CITY OF MEMPHIS
COUNCIL AGENDA CHECK OFF SHEET

Memphis City Council
Summary Sheet

PD 2025-008

RESOLUTION PURSUANT TO CHAPTER 9.6 OF THE MEMPHIS AND SHELBY COUNTY UNIFIED DEVELOPMENT CODE APPROVING A PLANNED DEVELOPMENT AT THE SUBJECT PROPERTY LOCATED AT 4387 RALEIGH LAGRANGE, KNOWN AS CASE NUMBER PD 2025-008

SITE PLAN
ZONING DISTRICT: RU-3
CASE NO.: PD 2025-008
CONTRACTOR STORAGE WITH TREE & LAWN SERVICES
4387 RALEIGH LAGRANGE ROAD
SHELBY COUNTY, TENNESSEE

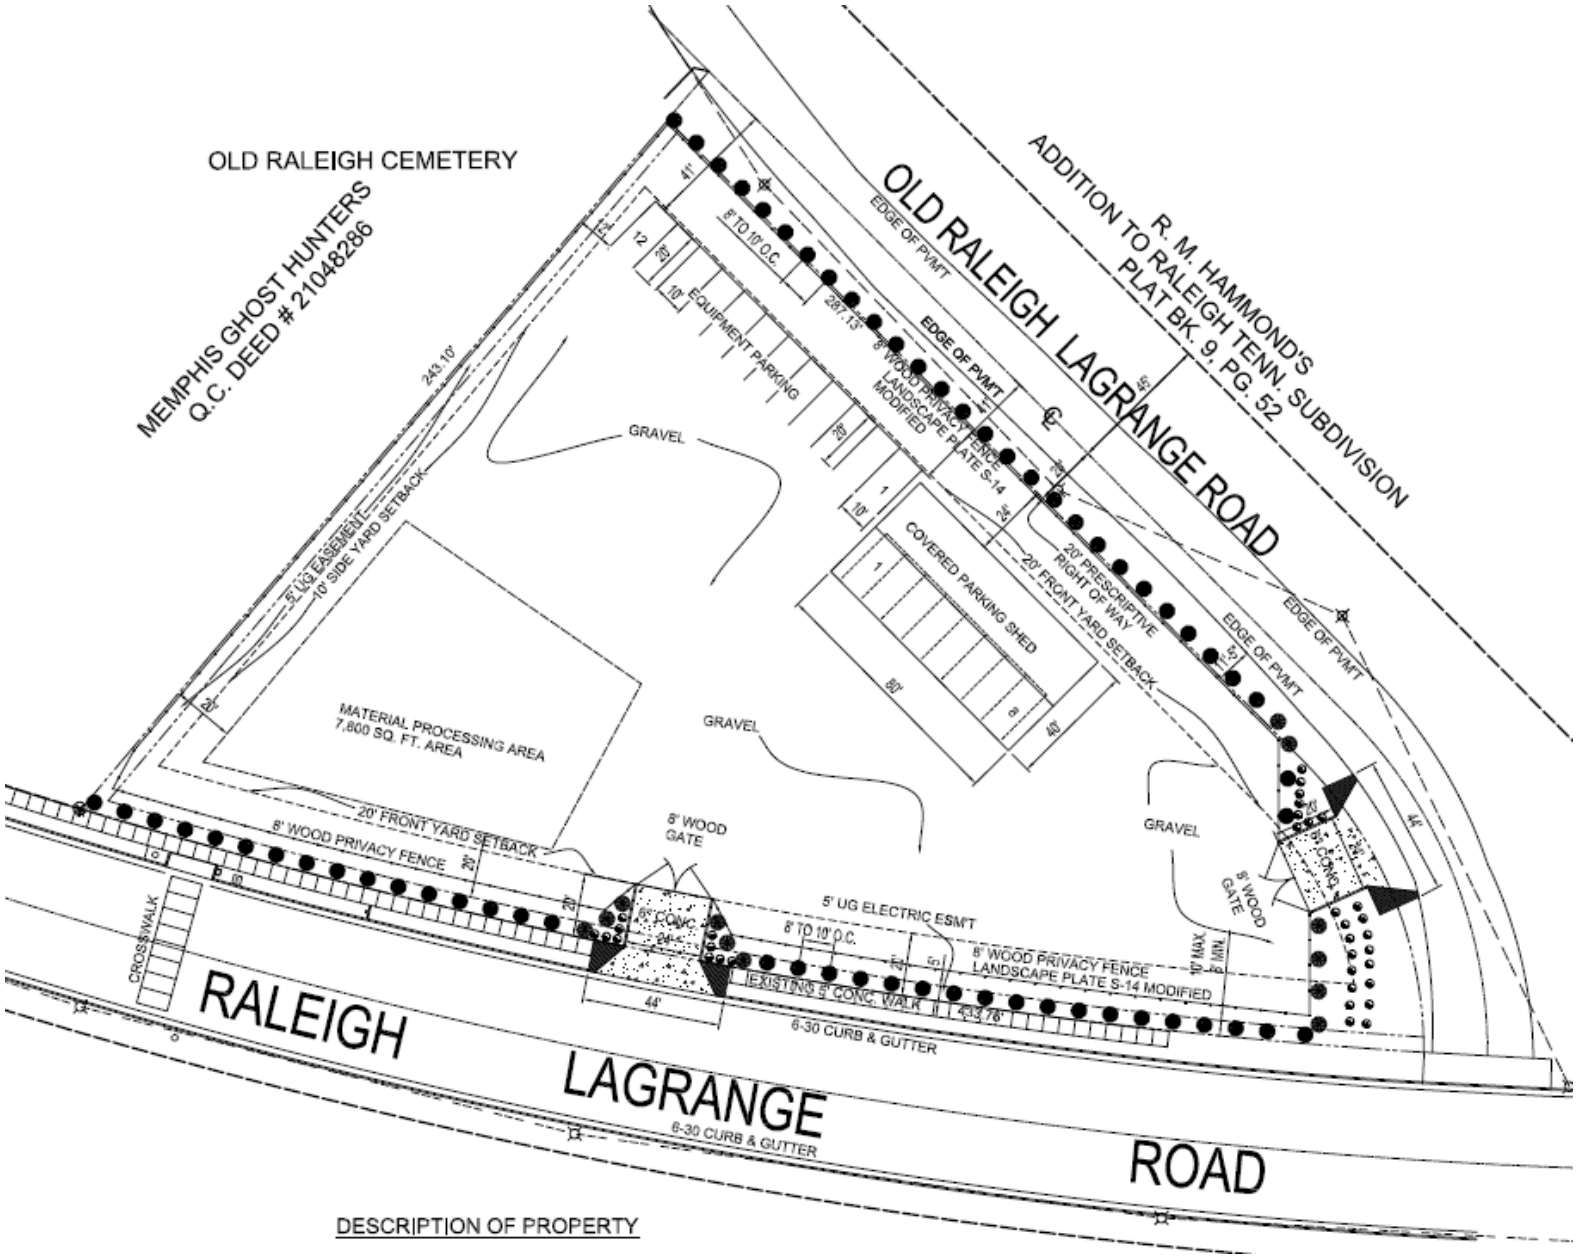
The applicant is proposing to establish Rey's Tree Service Planned Development to allow lawn, tree, and/or garden service with limited outdoor storage to include vehicle and equipment parking and overnight storage of wood and trees to be transferred the following business day. The applicant began operating at this location sometime between February 2022 – December 2024 based on Google Streetview data. The property is located within the Residential Urban – 3 zoning district and with a vacant land use designation. This property abuts Commercial Mixed Use – 1 zoning northeast, Phase 11 of the Wolf River Greenway trailhead runs into the southwest corner of the lot and there is heavy industrial zoned property located southeast that is located in the floodplain.

Although, the applicant is proposing to establish proper landscaping and fencing. Due to the topography of the subject property, commuters and neighborhood members will be able to see interior beyond the fencing and landscaping possibly until Leyland Cypress tree plantings reach mature height.

Despite the non-residential zoning districts surrounding the property, there are also multi-family and single-family developments in proximity. The only industrial zoned property in the immediate vicinity of the subject property is owned by the City of Memphis and designated as John F. Kennedy Park. Comprehensive Planning finding this proposal incompatible with the Anchor Neighborhood-Primarily Single-Unit (AN-S) future land use is also supported by staff given the location of the Greenway and its accessibility. Also, staff was unable to locate any permits/certificates related to any improvements or occupancy at the subject property.

Staff recommends rejection; however, if approved, staff recommends the following revisions to the outline plan conditions:

A. The entire property shall be screened with an 8 to12 foot wood privacy fence (plate 14 modified) ~~with barbed wire on the top~~ and Leyland Cyprus trees on the street side of the fence along Raleigh LaGrange and old Raleigh LaGrange as depicted in on the site plan.

STREETSCAPE S-14 (MODIFIED)

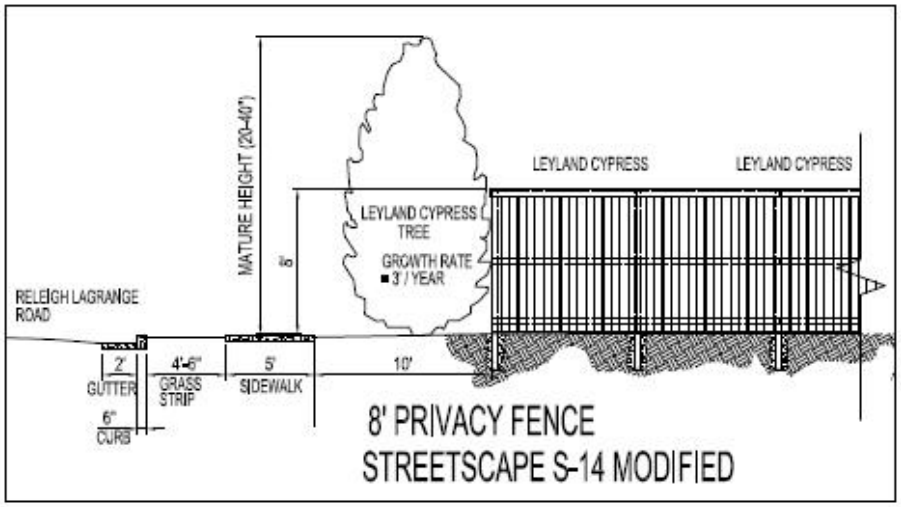
- There will be an S-14 modified streetscape installed along Raleigh LaGrange Road and Old Raleigh LaGrange Road with the planting of Leyland Cypress trees.
